LiDAR Quality Assessment Report

Materials Received: 1/6/2012	Project Type: NSDI Agreement				
	Project Description:				
Project ID:	Rock County is one of the 25 counties as				
MN_MNRiverBasin-Phase1_2010	part of the Minnesota River Basin - Phase				
	1 lidar project.				
Project Alias(es):					
MN_RockCo_2010	Year of Collection: 2010

Lot 20 of 25 lots.

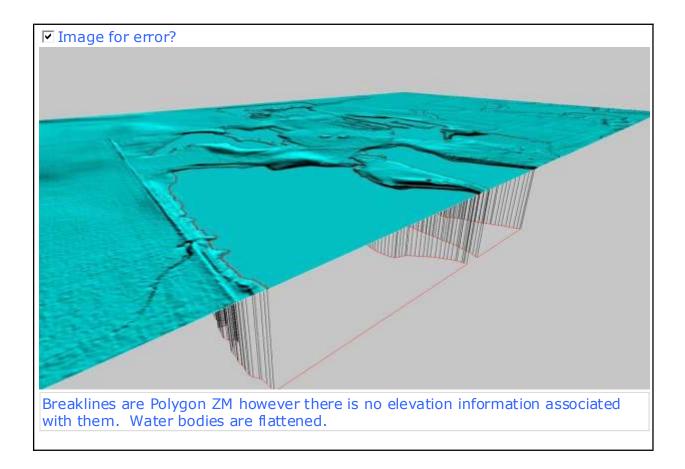
- One pond was not completely flattened; vegetation in water.
- FVA and CVA were reported in RMSEz.
 - The FVA, reported as 6.4 RMSEz = 12.54 cm Accuracy_z at 95% confidence interval; the NGTOC calculated FVA at the 95% confidence interval is 20.7 cm... which is less than the target 24.5 cm, thus it passes.
 - The CVA reported at 7.6 RMSEz was not reported at the 95th percentile; the NGTOC calculated CVA at the 95th percentile at 24.6 cm...which is less than the target 36.3 cm, thus it passes.
